ADDENDUM NO. 4

Project Name: Interior Renovation of the Indian River County Building and Fire Departments

Bid Number: 2020057

This addendum is being released to answer questions received to date and to modify the plans and specifications.

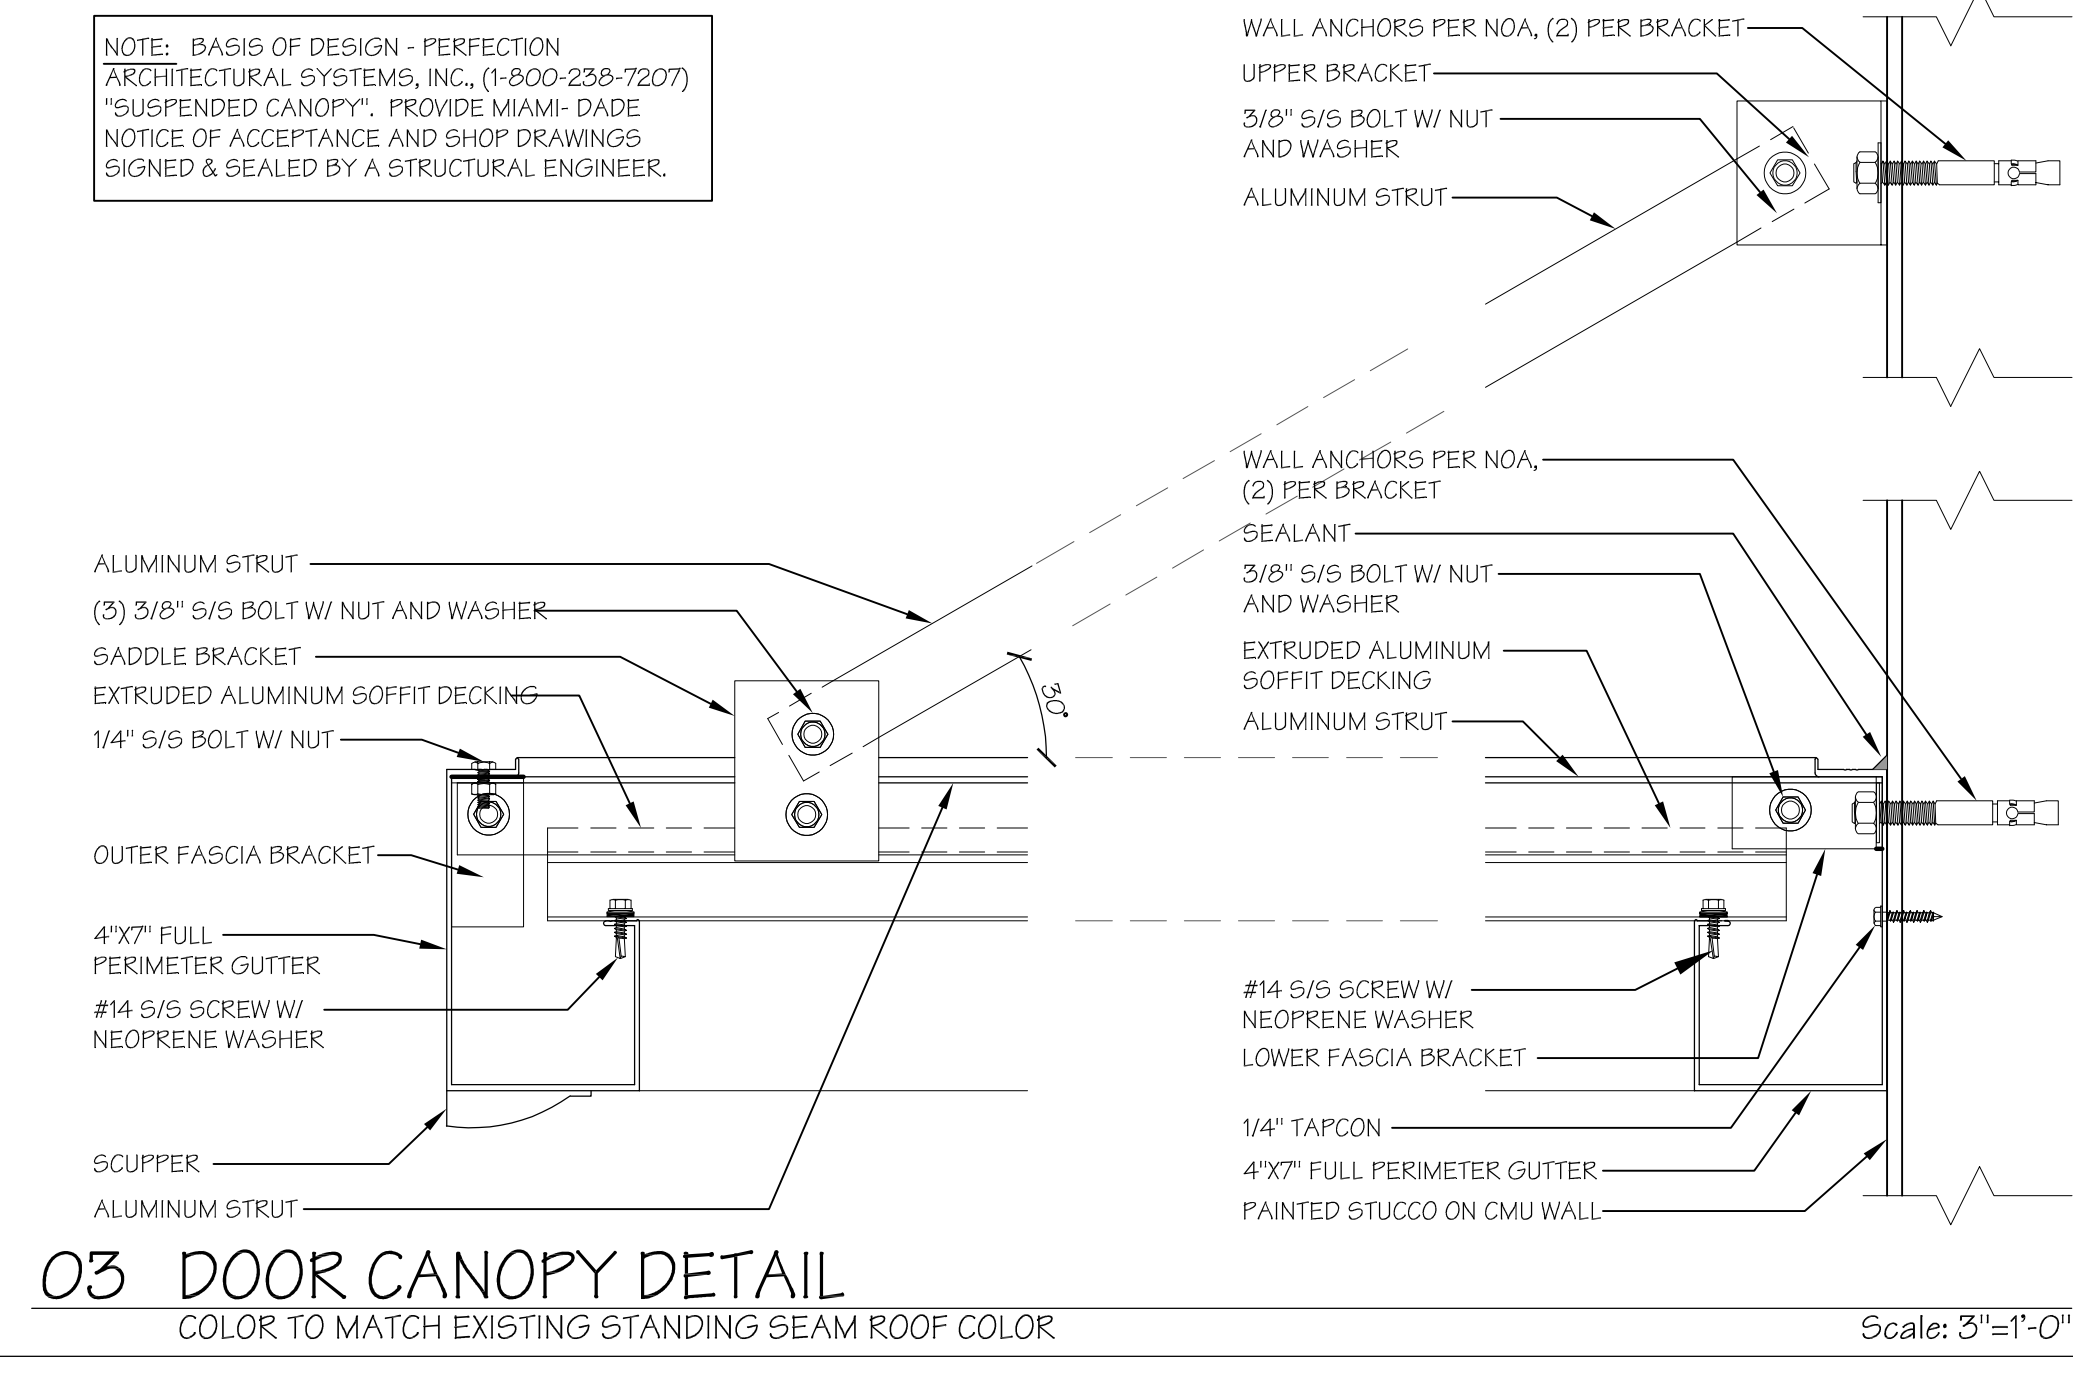
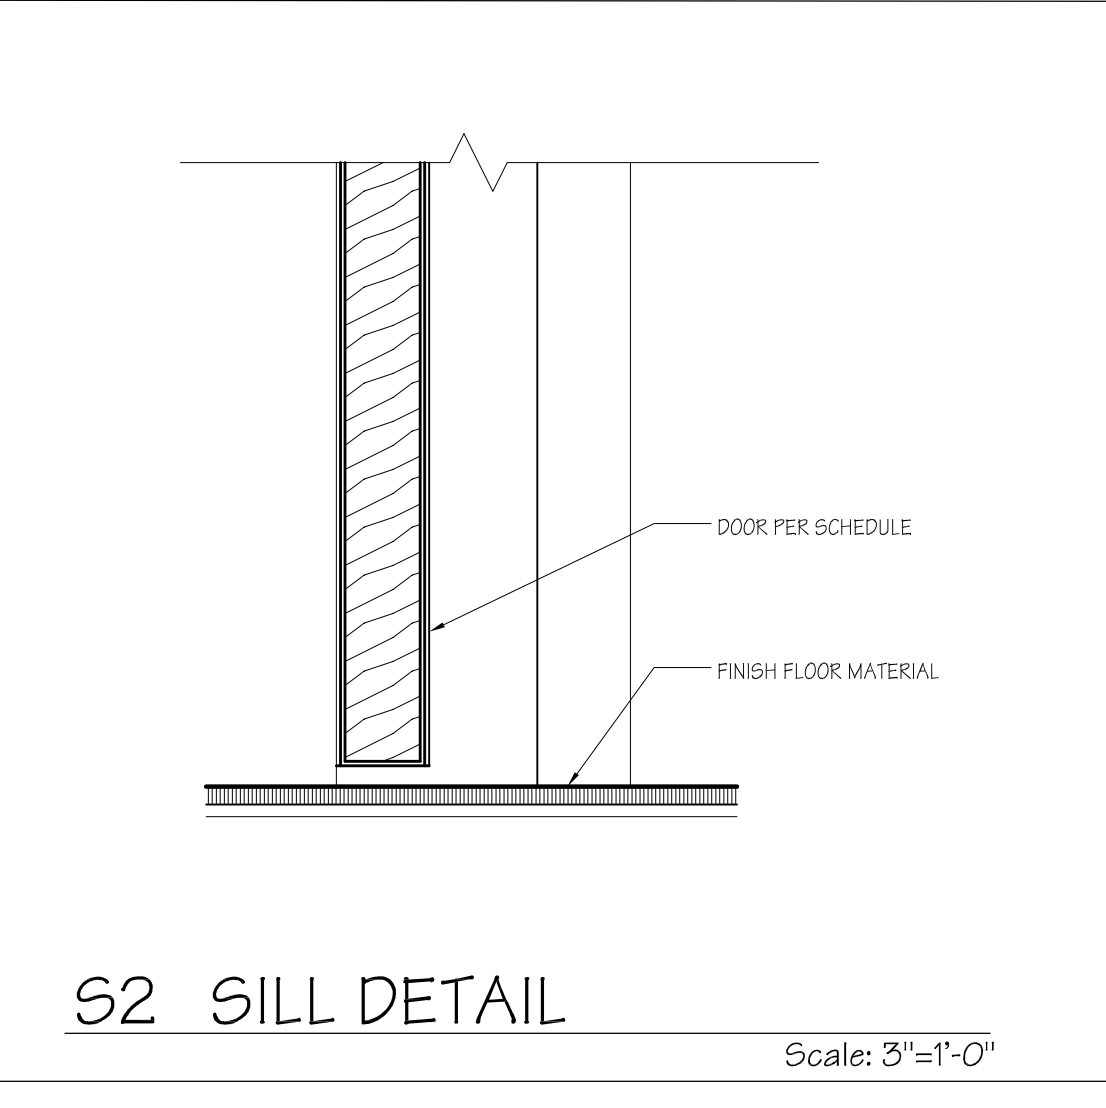
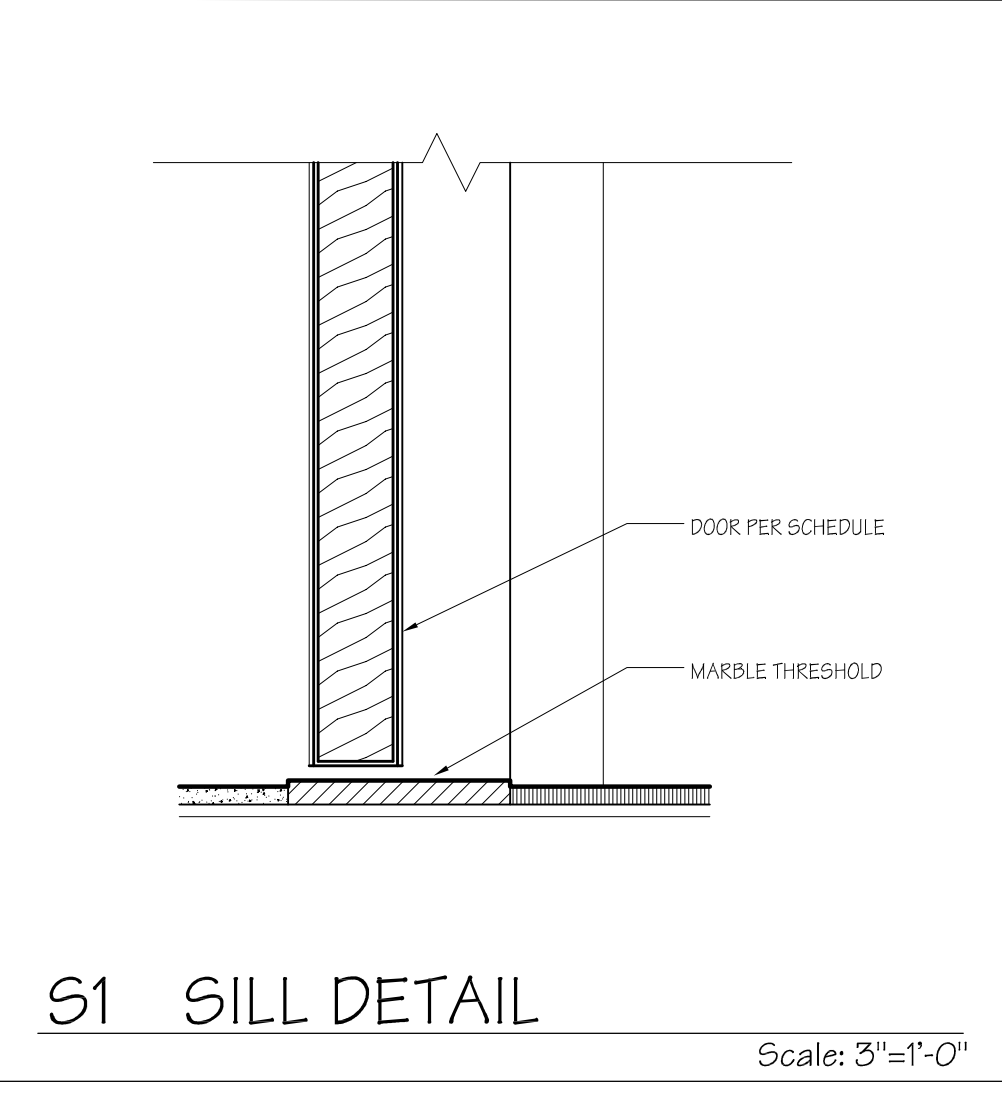
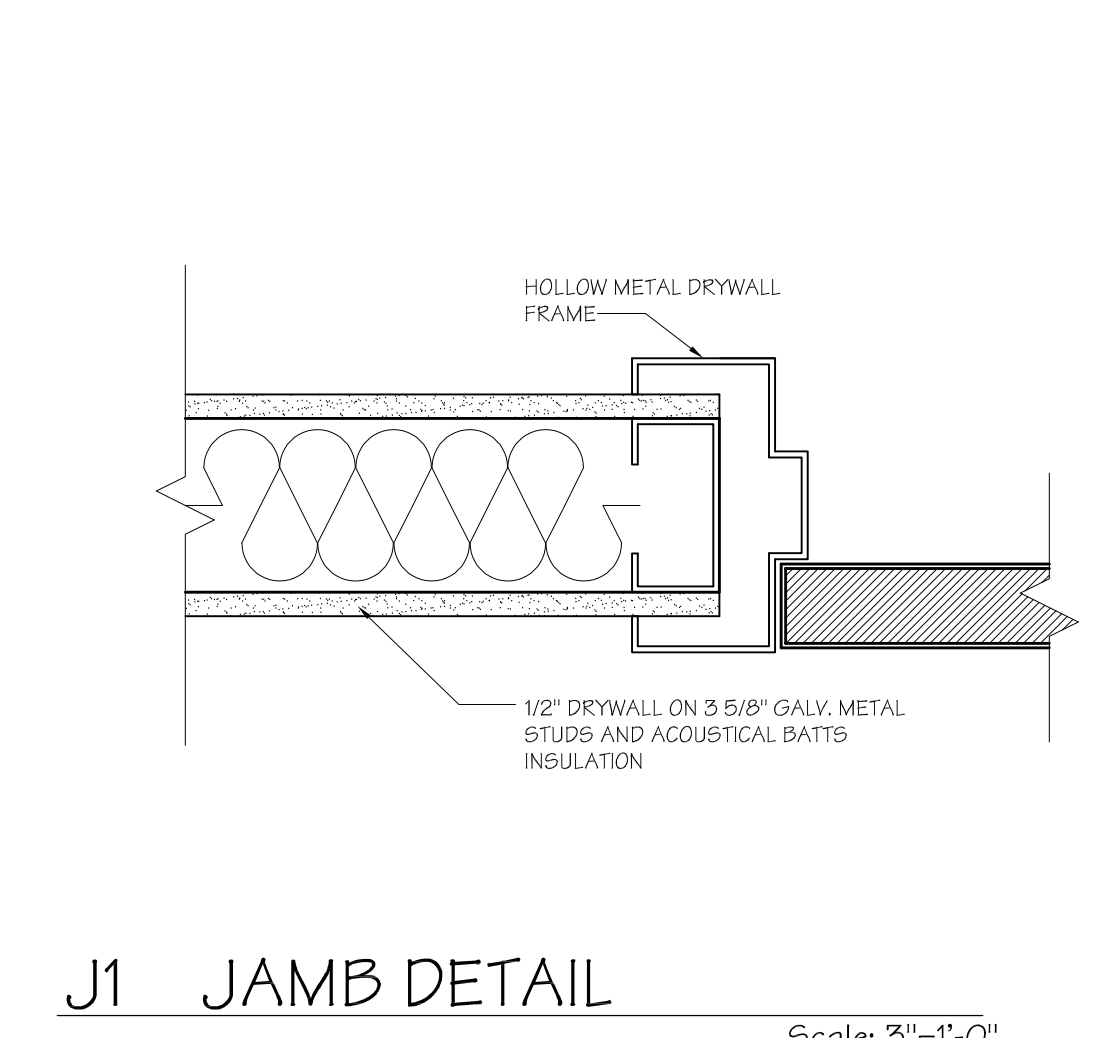
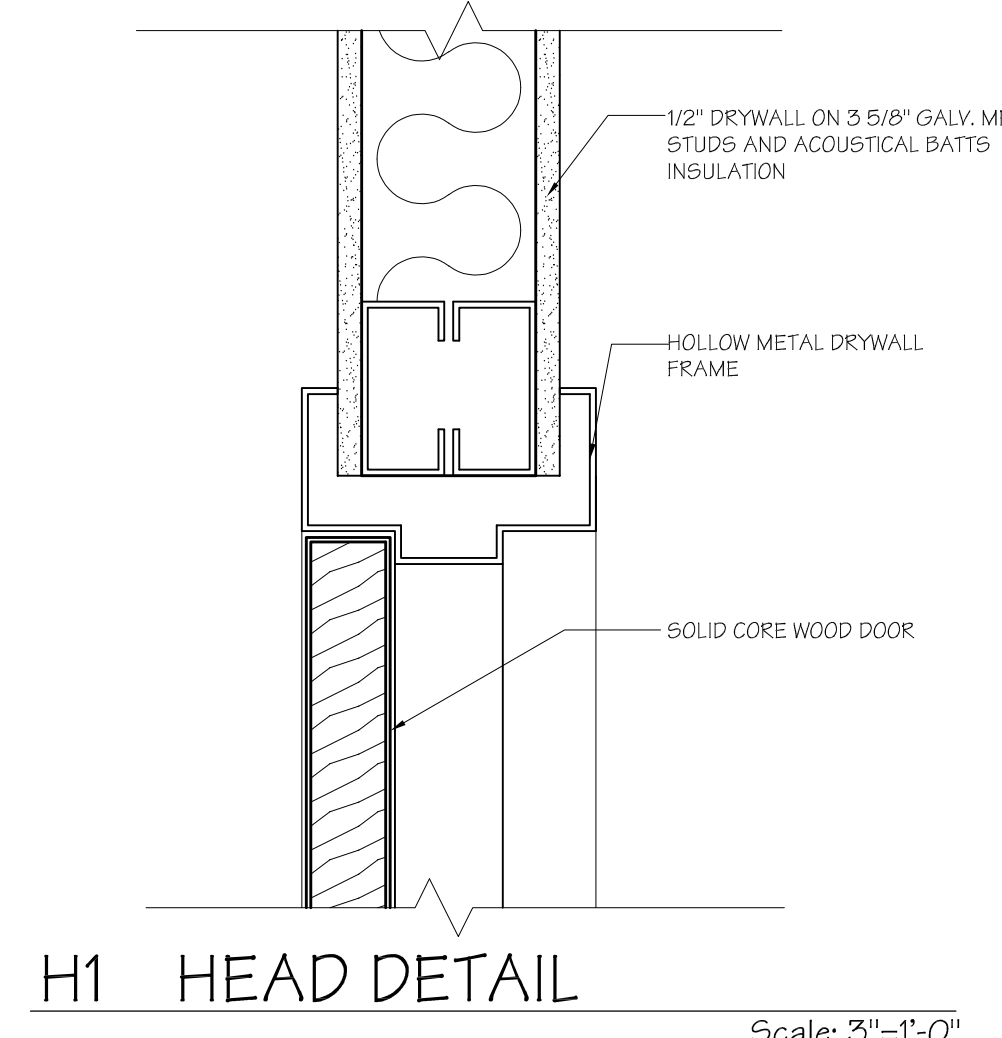
4. Please furnish dimensions for size of the exterior aluminum canopies.
Canopies to be 4'-8" wide by 3'-0" deep.

NOTE: BASIS OF DESIGN - PERFECTION ARCHITECTURAL SYSTEMS, INC., (1-800-238-7207) "SUSPENDED CANOPY". PROVIDE MIAMI-DADE NOTICE OF ACCEPTANCE AND SHOP DRAWINGS SIGNED & SEALED BY A STRUCTURAL ENGINEER.
